PROPOSAL FOR DRAFT AMENDMENTS TO REGULATION No. 48

(Installation of lighting and light-signalling devices)

Transmitted by the Expert from the Working Party "Brussels 1952" (GTB)

Apparent surfaces of lighting units 1 through 11 of an AFS (example)

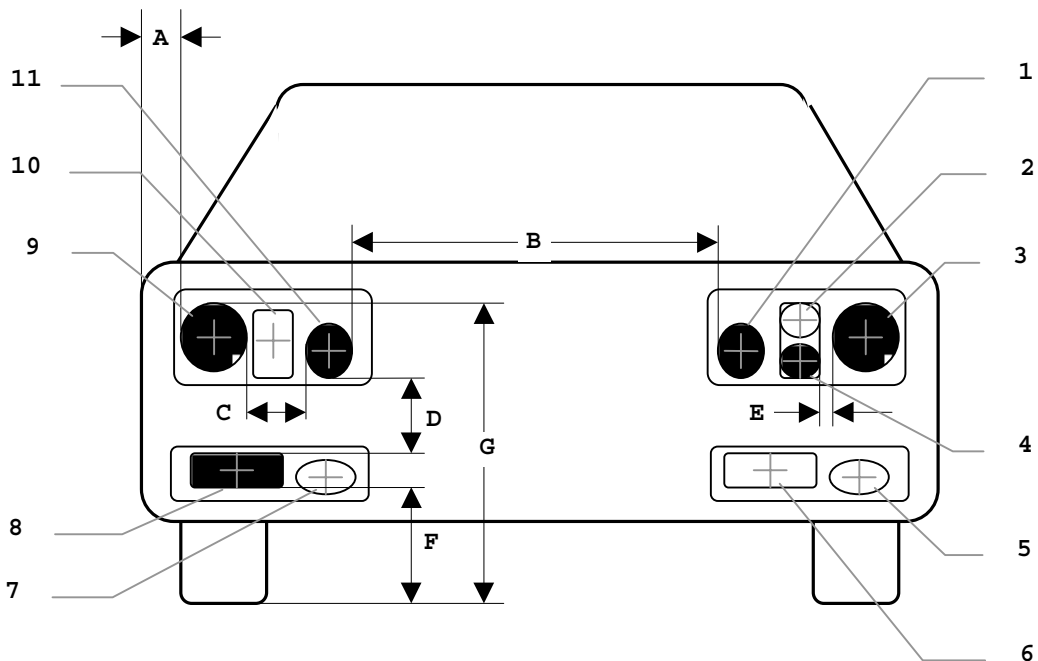
The AFS shall, prior to the subsequent test procedures, be set to the neutral state, emitting the basic passing beam;

Lighting units being simultaneously energized for a given lighting mode:

- No.3 and 9: two symmetrically placed lighting units
- No.4 and 8: two additional lighting units
- No.1 and 11: two symmetrically placed lighting units

Lighting units not being energized for said lighting mode:

- No.2 and 10: (two symmetrically placed lighting units)
- No.5: (additional lighting unit)
- No.6 and 7: (two symmetrically placed lighting units)

horizontal dimensions in mm:

- A ≤ 400
- B ≥ 600 or ≥ 400 if vehicle overall width <1300 mm, however
no requirement for category M1 and N1 vehicles
- C ≤ 200
- E ≤ 140

vertical dimensions in mm:

- D ≤ 400
- F ≥ 250
- G ≤ [950 /1200 /1500]

6.20.4.1.2. *Additional lighting units, if any, on either side of the vehicle shall be positioned at a distance not exceeding 140 mm $\overline{7}$ in horizontal direction (E in the figure) and 400 mm in vertical direction above or below (D in the figure) from the nearest lighting unit;*

6.20.4.1.3. *None of the additional lighting units described in paragraph 6.20.4.1.2. above shall be positioned lower than 250 mm (F in the figure) nor higher than [950 /1200 /1500] mm (G in the figure) above the ground;*

the outer edge of the apparent surface of at least one lighting unit on each side of the vehicle shall not be more than 400 mm from the extreme outer edge of the vehicle (A in the figure); and,

the distance between the inner edges of the apparent surfaces of the lighting units on the right and left hand side of the vehicle (B in the figure) shall be not less than 600 mm, or, except for category M₁ and N₁ vehicles not less than 400 mm when the overall width of the vehicle is less than 1300 mm.

$\overline{7}$ In case of additional "two symmetrically placed lighting units" the horizontal distance may be 200 mm (C in the figure).
